# **Cleveland City Planning Commission**

July 18, 2025

## **AGENDA**

**CSE2025-026** – 6806 Harvard, Car Sales Lot w/ Office

ARCHITECTURAL SITE PLAN  
SCALE: 1" = 40'-0"

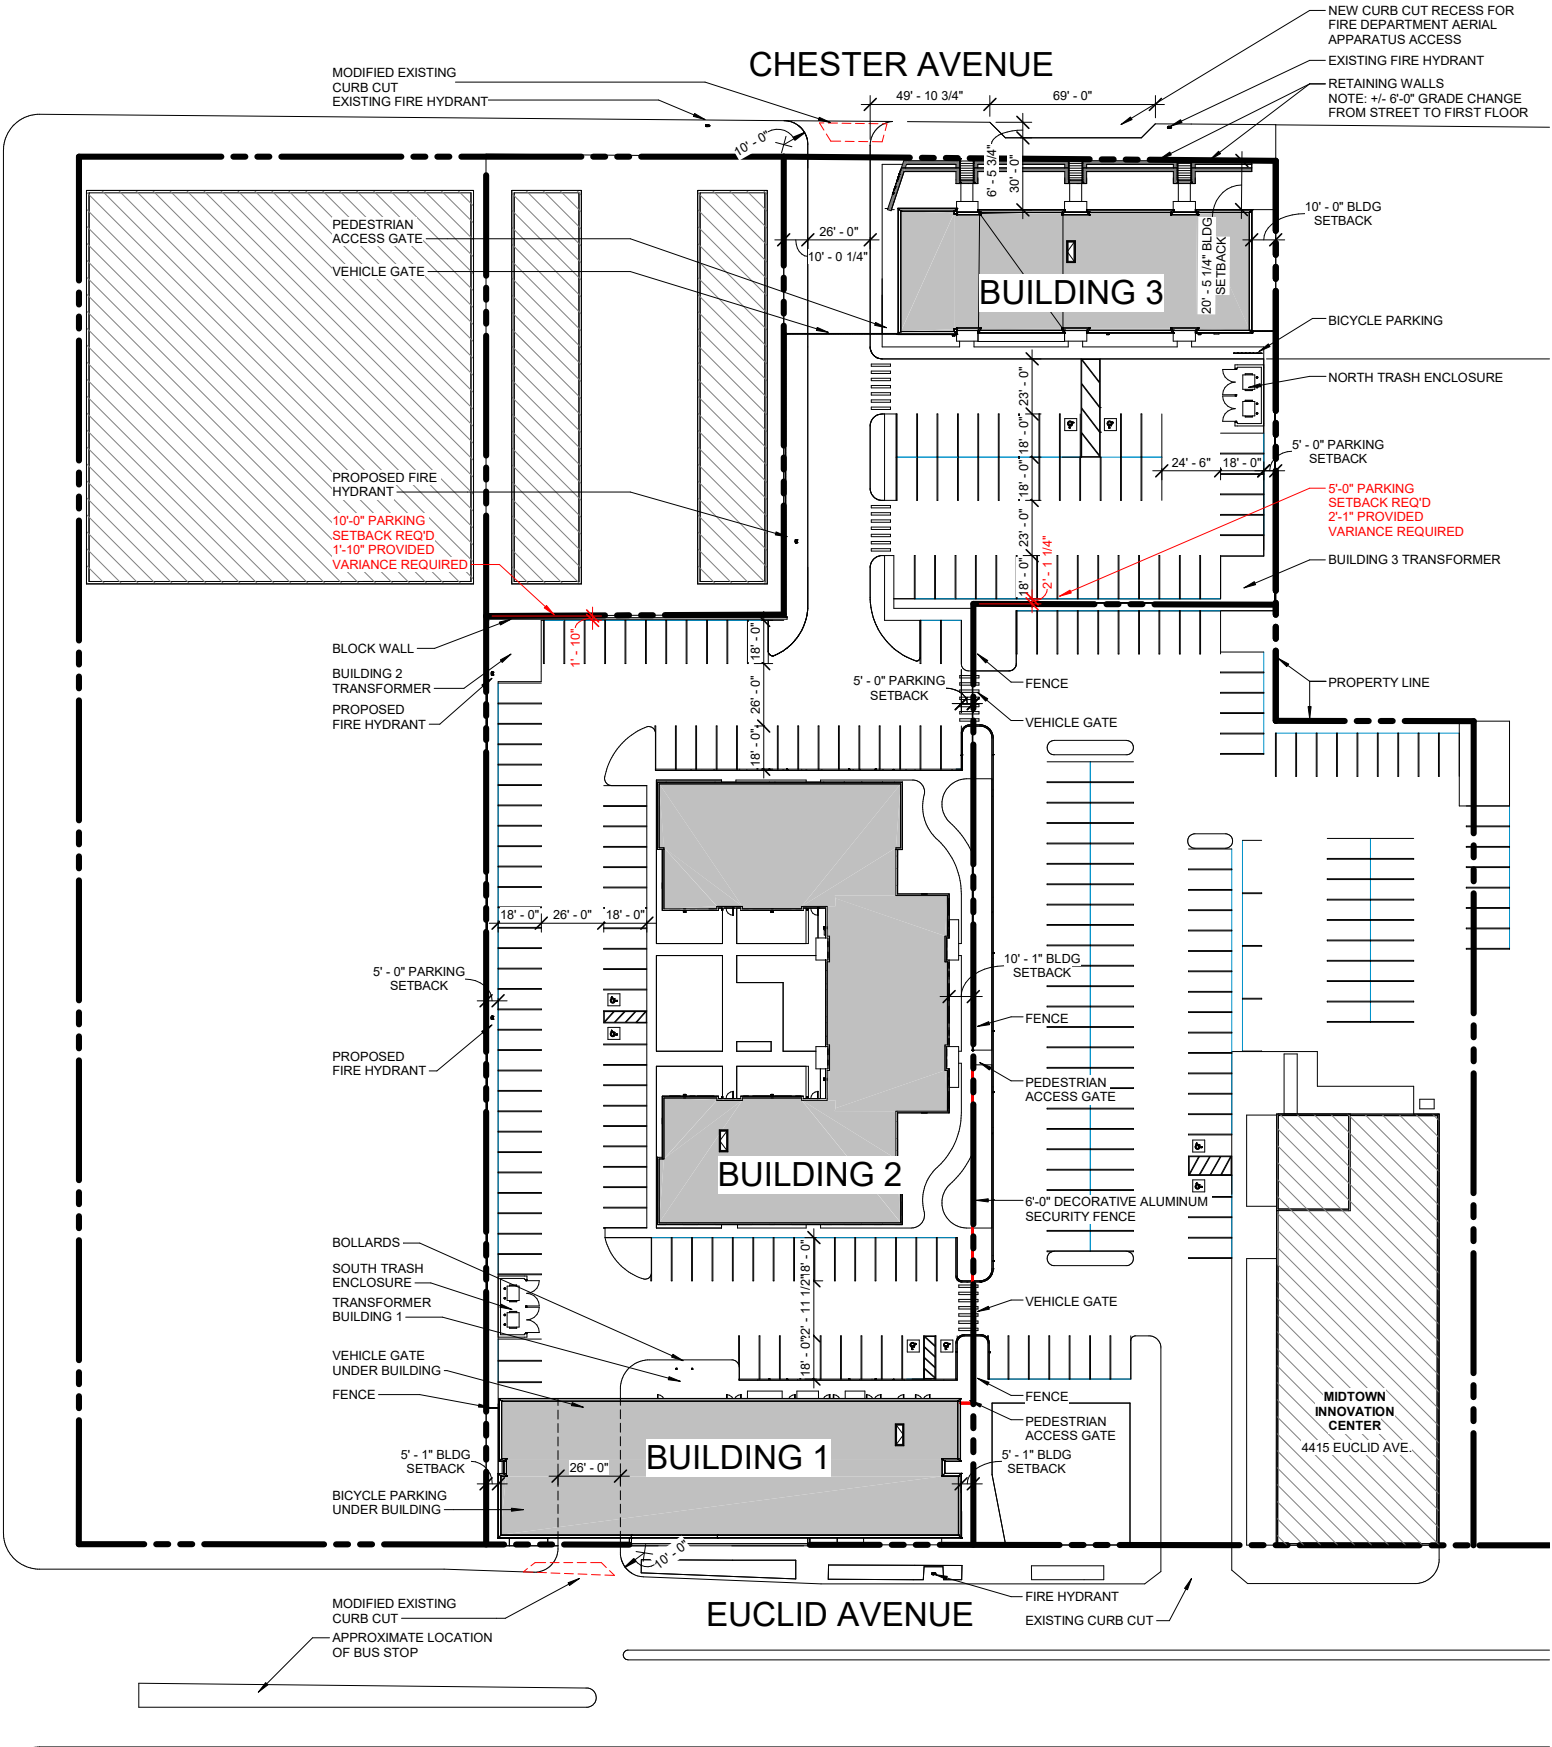
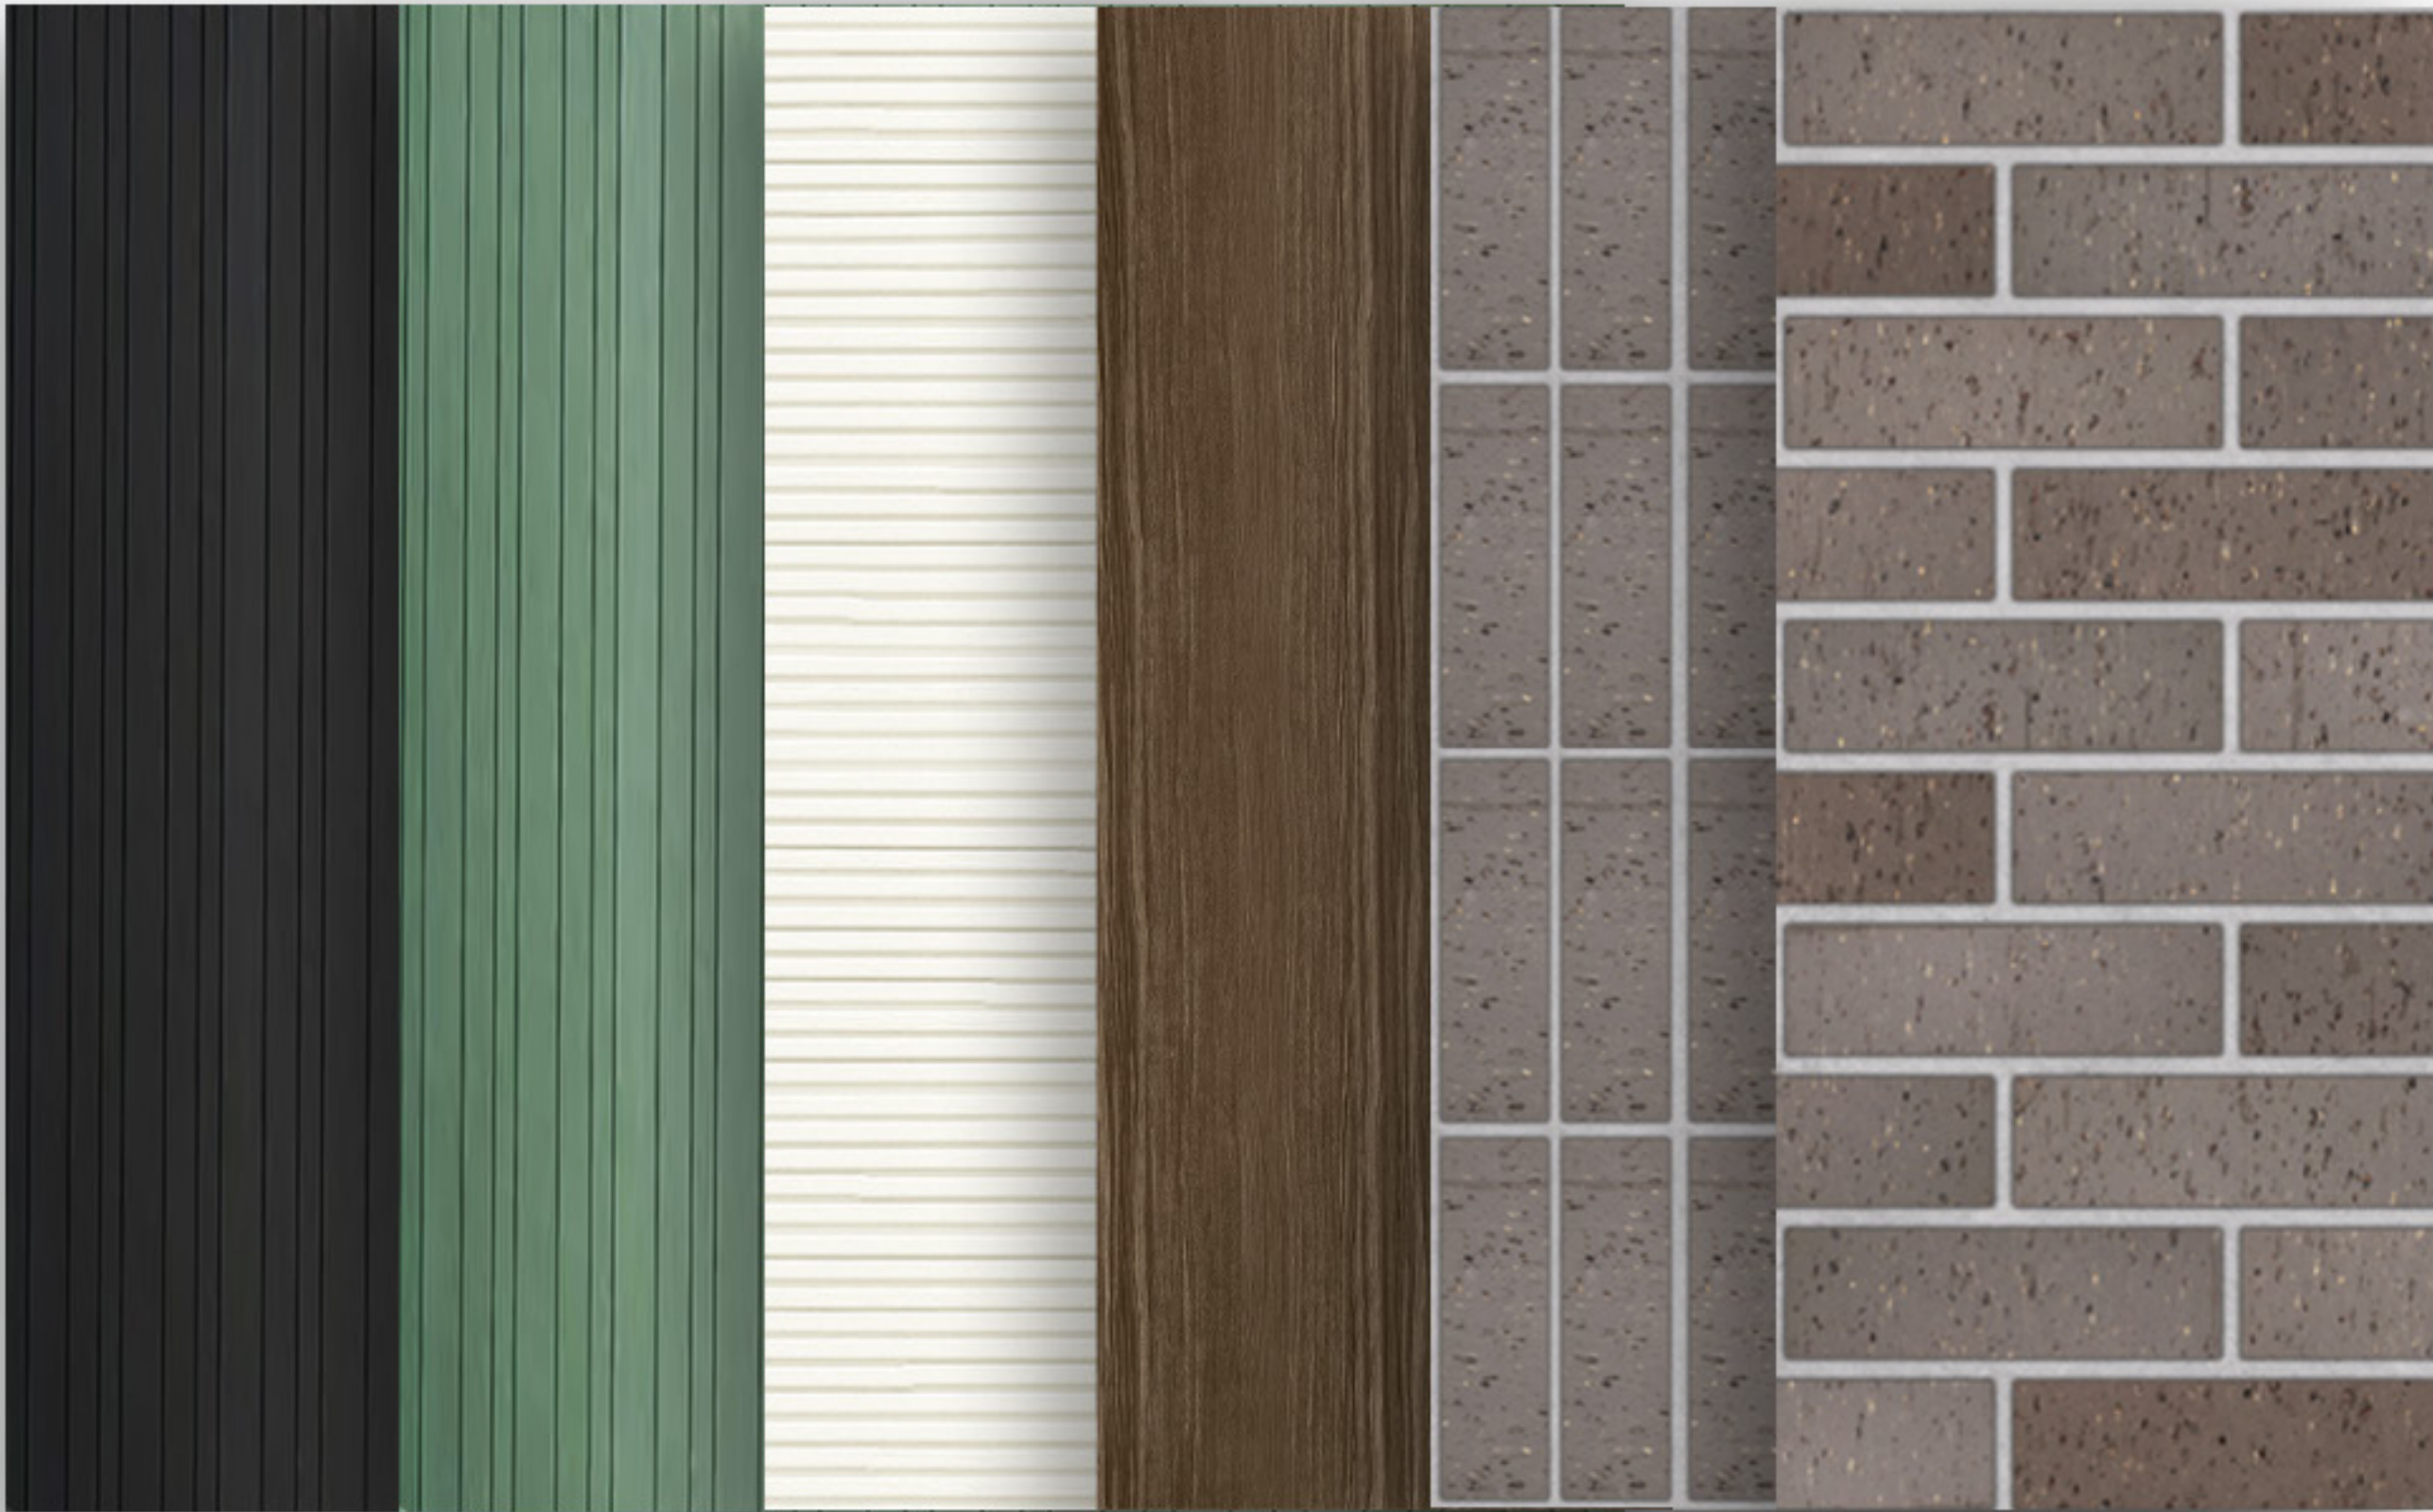
- Additional studies on parking count and on level of detailing along Euclid Ave building
  - Comment regarding window pattering at the end of each building, showing each end of the building in more rendering angles.
-
